From: Comar, Manny
Sent: Thursday, November 01, 2012 5:03 PM
To: TurkeyCOL Resource
Subject: FW: DRAFT RAI Responses FPL Turkey Point 6 & 7 for eRAI 6006 - Stability of Subsurface Materials and Foundations
Attachments: Draft Revised Response for NRC RAI Letter No. 040, RAI 02.05.04-17 (eRAI 6006).pdf; Draft Revised Response for NRC RAI Letter No. 040, RAI 02.05.04-10 (eRAI 6006).pdf

NRC RAI Letter No. PTN-RAI-LTR-040

SRP Section: 02.05.04 - Stability of Subsurface Materials and Foundations

NRC RAI Number: 02.05.04-17 (eRAI 6006)

Figure 1
Factor of safety against liquefaction based on CPT values
(reproduced from FSAR Figure 2.5.4-238)

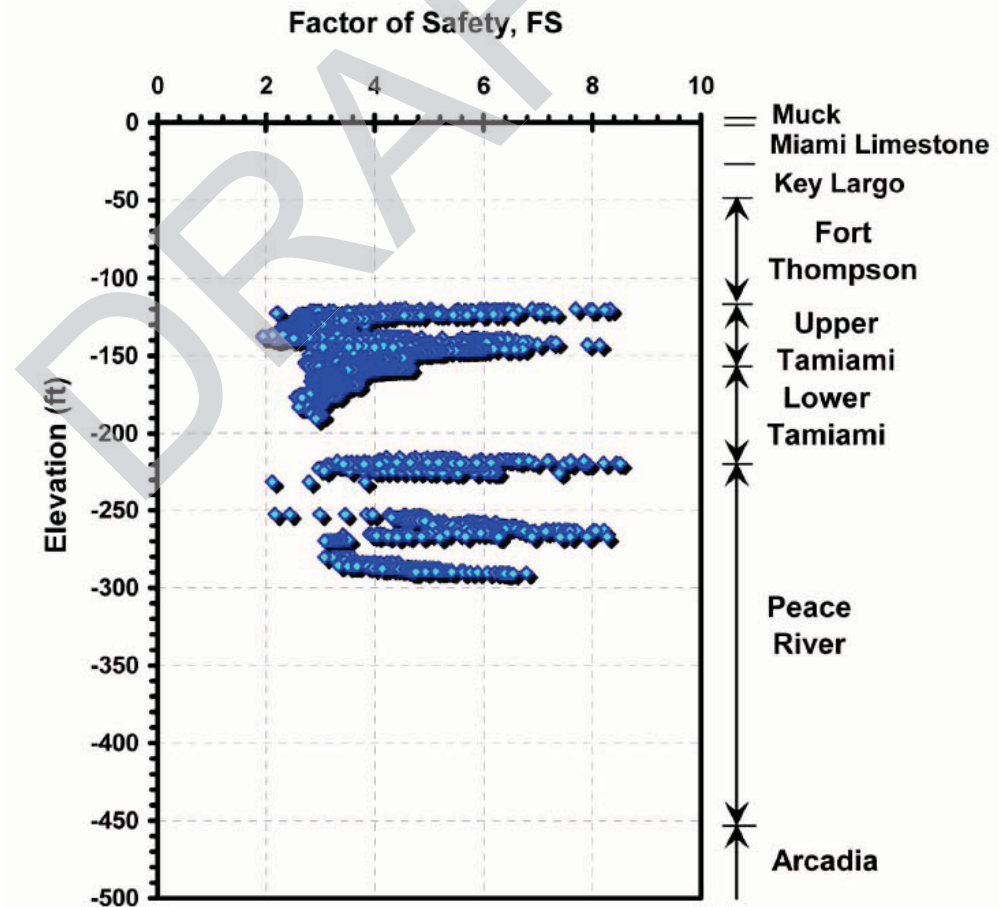
- a. Clarify how the method used for determining SR_{DRS} meets the ground motion level requirements for liquefaction analysis per 10 CFR 50, Appendix S. The $GRMS$ initially resulted in a PGA of less than 0.1g and was scaled upwards per RG 1.208. Since the method used for determining the SR_{DRS} is the same as the $GRMS$, describe how this method provides stress ratio values that are comparable to those calculated using a PGA value of at least 0.1g.

FSAR Figure 2.5.4-238, which is reproduced as Figure 1 in this response, is a compilation of the four CPT data sets and presents the FOS values that are based on the CSR values from P-Shake analysis as a function of elevation. The three lowest FOS values that correspond to the CPT measurements at three different elevations are selected from this figure for comparison purposes. The FOS of 1.92 at El. -137.7 ft, 2.11 at El. -231.5 ft, and 2.16 at El. -252.3 ft (NAVD 88) are tabulated below, along with their corresponding CSR values of 0.047, 0.043, and 0.043.

For re-evaluation purposes, the CSR values for the same data points are recalculated using a PGA of 0.1g. Using Equations 1, 2a and 2b of FSAR Subsection 2.5.4 Reference 219, the corresponding CSR values are computed as 0.060, 0.064, and 0.065, respectively. Thus, the CSR values based on a PGA of 0.1g are increased compared to those directly obtained from the site-specific P-Shake analysis. As a result, because there is an inversely proportional relationship between the CSR and FOS values, substituting the CSR values from 0.1g will reduce the corresponding FOS values. Thus, the FOS values computed using a PGA of 0.1g at El. -137.7 ft, -231.5 ft, and -252.3 ft are 1.50, 1.42, and 1.43, respectively. As indicated in FSAR Subsection 2.5.4.11, the minimum allowable FOS of 1.25 was conservatively selected as the trigger value for the liquefaction analysis of site soils. Given that RG 1.198 considers soils with a FOS value less than 1.1 as liquefiable, there is about 14% conservatism employed in the analysis (1.1 versus 1.25). Nonetheless, the FOS values of 1.50, 1.42, and 1.43 exceed the minimum allowable FOS of 1.25.

In summary, using a PGA of 0.1g in calculation of CSR values will reduce the FOS values against liquefaction. However, as observed above, the latter FOS values exceed the minimum allowable FOS of 1.25. Thus, no modifications are proposed to the approach presented in the FSAR.

The footnote to FSAR Figure 2.5.4-238 will be deleted as follows in a future FSAR revision.

~~Data from Reference 257~~

Figure 2

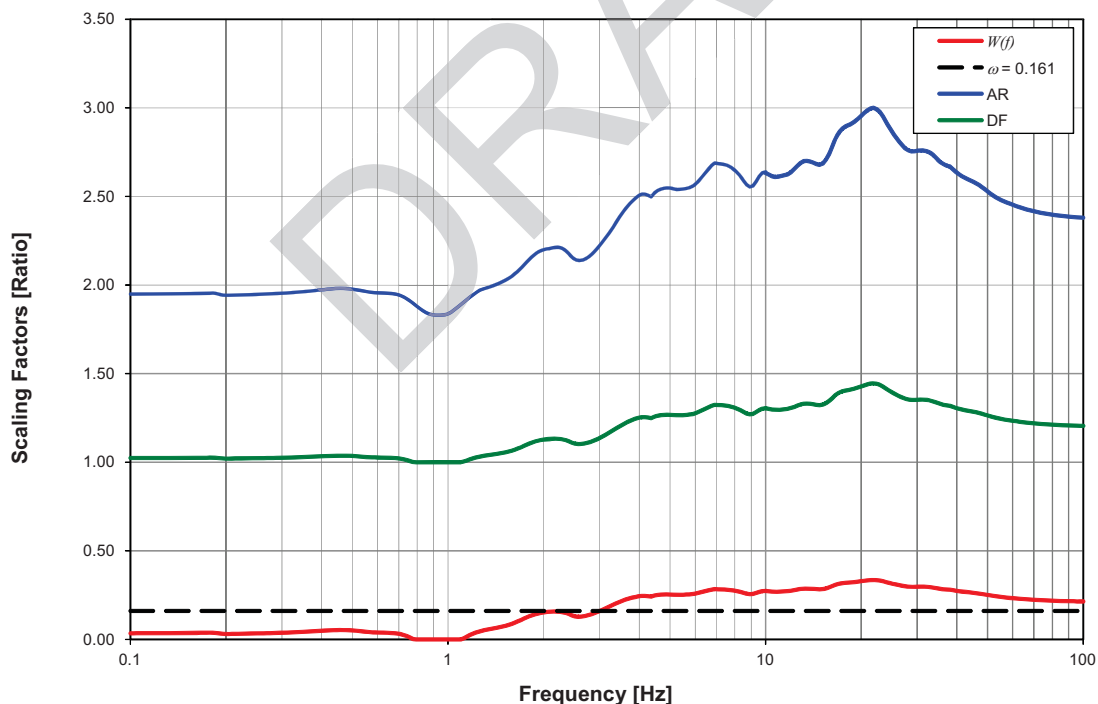
- b. Describe how the amplitude ratio $A_R(f)$, defined by $(ARS_{10-5}) / (ARS_{10-4})$ and used in the determination of the weighting factor w , correlates to the ratio of the in-situ *stress ratios* resulting from site response analysis using the ARS_{10-5} and ARS_{10-4} as input spectrums.

The weighting factor approach results in stress ratios that are compatible with the design response spectrum (DRS), that is larger than stress ratios compatible with 1E-4 seismic motion, and lower than stress ratios compatible with 1E-5 seismic motion. The amplitude ratio $A_R(f)$ correlates positively to the weighting factor $W(f)$ as shown in Figure 2. Stress ratios are calculated using the following equation:

$$SR_{DRS} = (SR_{10-4})^{1-\omega} (SR_{10-5})^{\omega}$$

Where ω is the average $W(f)$ over the entire frequency range. Note that the larger the value of ω the smaller the contribution of SR_{10-4} and the larger the contribution of SR_{10-5} . Therefore, the amplitude ratio A_R also correlates positively to the resulting stress ratios SR_{DRS} .

Figure 3

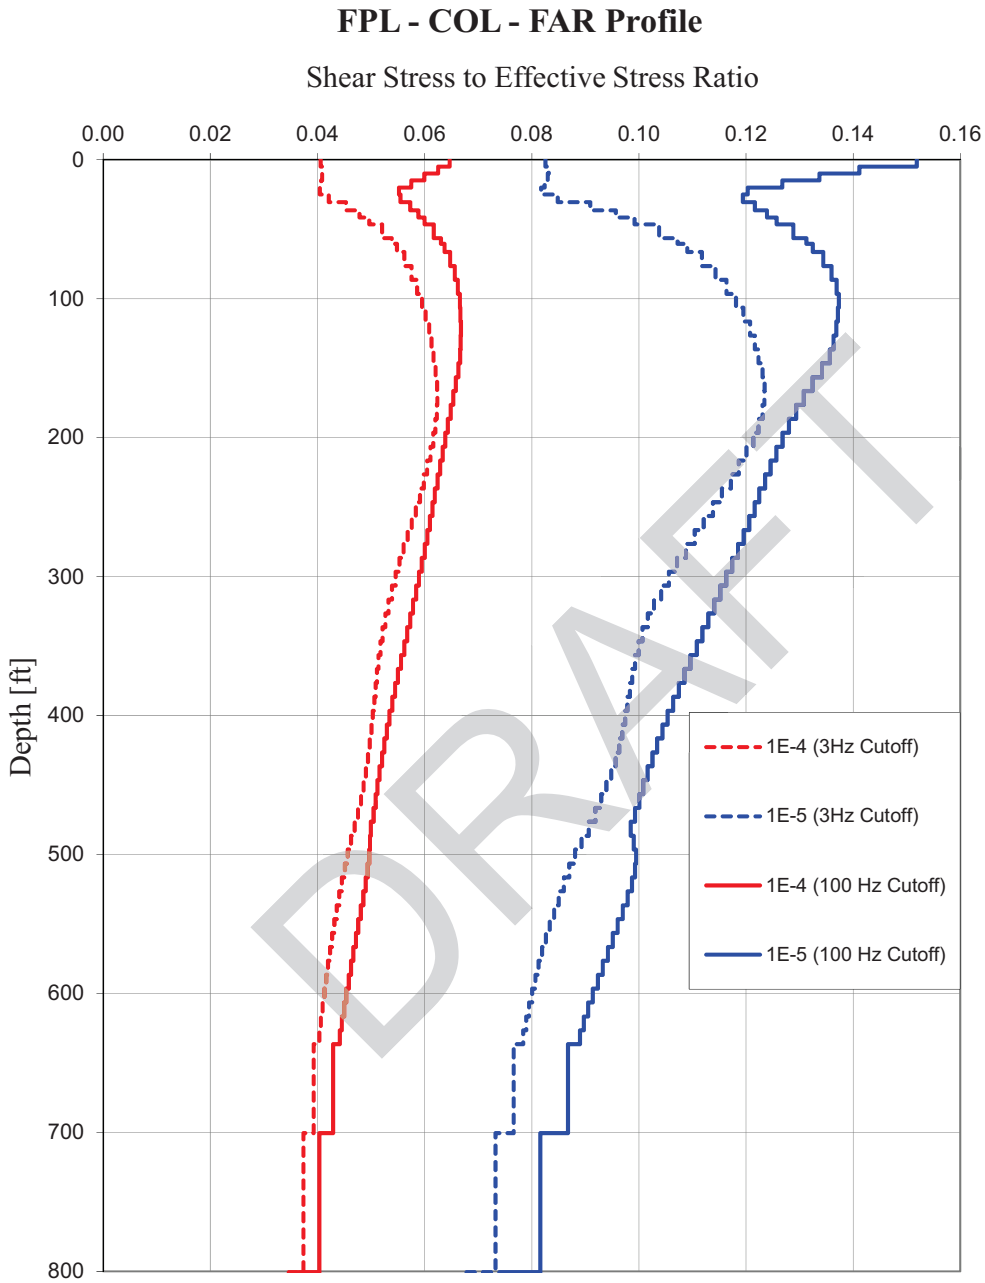
- c. The weighting factor w applied to the stress ratios SR_{10-4} and SR_{10-5} for the determination of SR_{DRS} is based on the average of the weighting factor $W(f)$. Justify using an average value of $W(f)$ over all frequencies, and describe how this is a conservative approach.

The average weighting factor w is larger than the calculated frequency-dependent weighting factors below a frequency of 3 Hz, but smaller at frequencies larger than 3 Hz. To justify the adequacy of the adopted average weighting factor for the purpose of calculating conservative stress ratios for use in liquefaction analysis, the following was performed.

The site response analysis runs, using P-SHAKE, are repeated for the FAR soil column with an imposed cutoff frequency of analysis of 3 Hz, as opposed to the cutoff frequency of 100 Hz in the case of the original analysis. The analysis was performed for all 60 simulated profiles subjected to the low frequency (LF) and high frequency (HF) rock motions at the 1E-4 and 1E-5 hazard levels. The resulting stress ratios, which as in the case of the original analysis are the envelope of LF and HF results, are compared in Figure 3 at the 1E-4 and 1E-5 hazard levels. Noting that the top-most submerged granular soil layer, analyzed for potential liquefaction, is at a depth of around 145 ft (Elevation -120 ft), it follows that the contribution of the motion, with frequency content removed above 3Hz, is more than 90% of the total stress ratios for all layers.

From Figure 2, note that for frequencies below 3 Hz the calculated frequency dependent weighting factor is much smaller than the adopted weighting factor of 0.161 used in the stress ratio calculation, with a computed average weighting factor of 0.054 for frequencies below 3 Hz. Similarly, in the case of the near NI soil column, and for frequencies below 3 Hz, the average weighting factor is 0.060, which is smaller than the adopted weighting factor of 0.154 used in the stress ratio calculation.

It is therefore concluded that the adopted (larger) weighting factor is conservative and adequately compensates for any small contribution to the weighting factor from frequencies above 3 Hz, confirming the adequacy of the calculated stress ratios used in liquefaction analysis.
